# Planning and Zoning Commission

## VETERINARY EMERGENCY GROUP - SIGNS 23-118MSP

### Case Summary

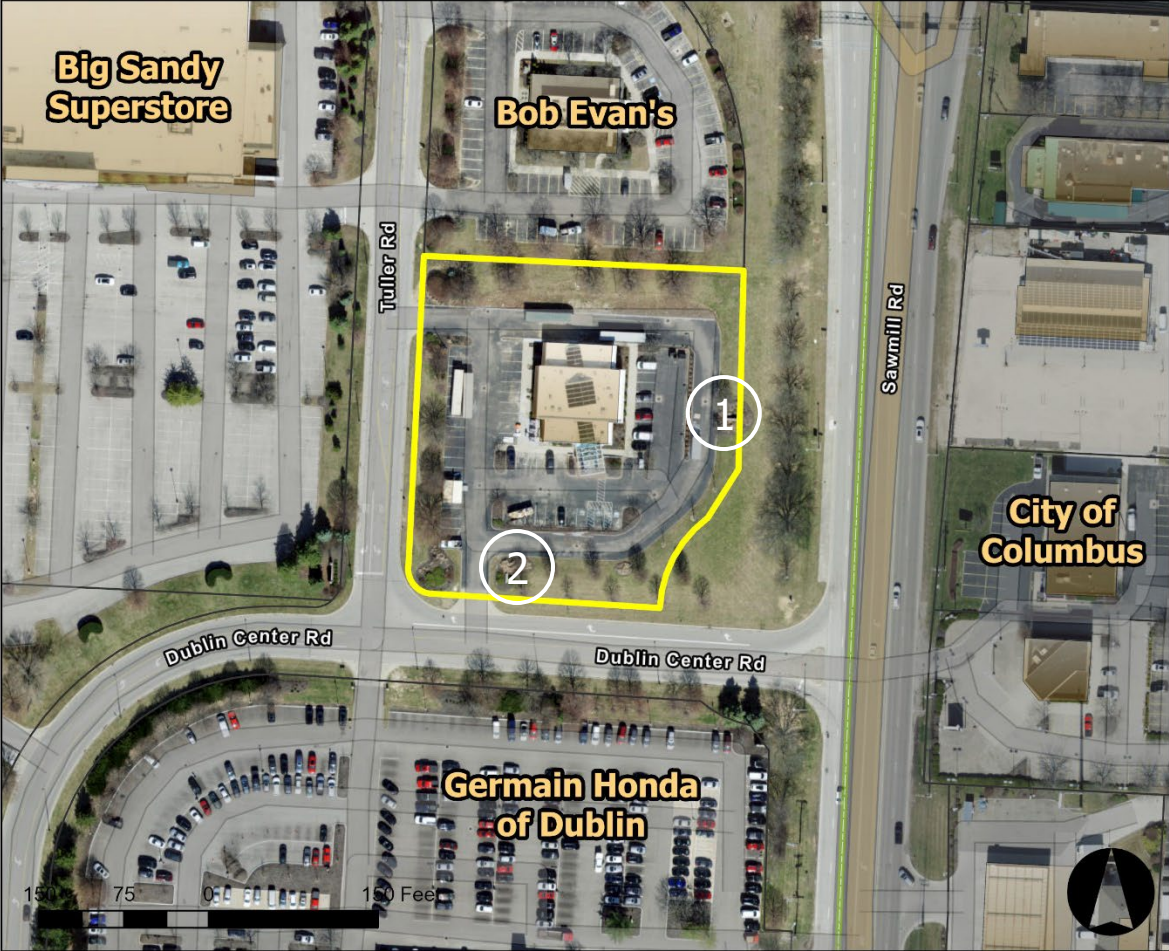
The applicant is proposing a wall sign on the east and west elevations of the building. Each sign is approximately 78.93 square feet, center-mounted at a height of 19-feet and 7-inches from grade to the top of the sign, and 3.5-inches deep.

Both wall signs exceed the maximum permitted height of 15 feet per the Standard Sign Code, Table 153.162, according to the permitted use. With the building architecture intact, it would be challenging for a proposed wall sign to meet the height requirements due to architectural limitations of the window height on the east and west elevations of the building. Staff is supportive of the proposed wall sign locations and mounting heights that are appropriately scaled and centered over the windows.

The proposed vinyl overlay for the channel lettering and logo deviates from permitted materials in the BSD Sign Guidelines. Staff is concerned with the longevity of a vinyl film and the on-going maintenance that would be required to maintain a good appearance. Staff finds that the vinyl overlay material is

inappropriate as proposed and deviates from a permitted sign material. To meet the Guidelines, staff recommends changing the sign face material to white acrylic. The PZC may approve alternative materials, as necessary, if determined the proposed materials provide appropriate high quality, durability, and design. A recommended condition of approval requests that the applicant work with staff to incorporate white acrylic in the channel letters for each wall sign prior to submitting for permanent sign permits. With the exception of the sign height and vinyl overlay, the proposed wall signs meet the Code and Guidelines.

- 1) The existing ground signs and all foundation components be immediately removed and the wall signs installed thereafter; at no point can the ground signs and wall signs be installed at the same time;
- 2) The applicant continues to work with staff to replace all vinyl overlay sign material with white acrylic, subject to staff review and approval prior to building permitting;
- 3) The applicant restores landscaping in place of the existing ground sign locations with matching plantings in the immediate area, to be reviewed and approved by staff prior to building permitting, and field inspected; and
- 4) The applicant submit and obtain permanent sign permits for both wall signs through Building Standards.
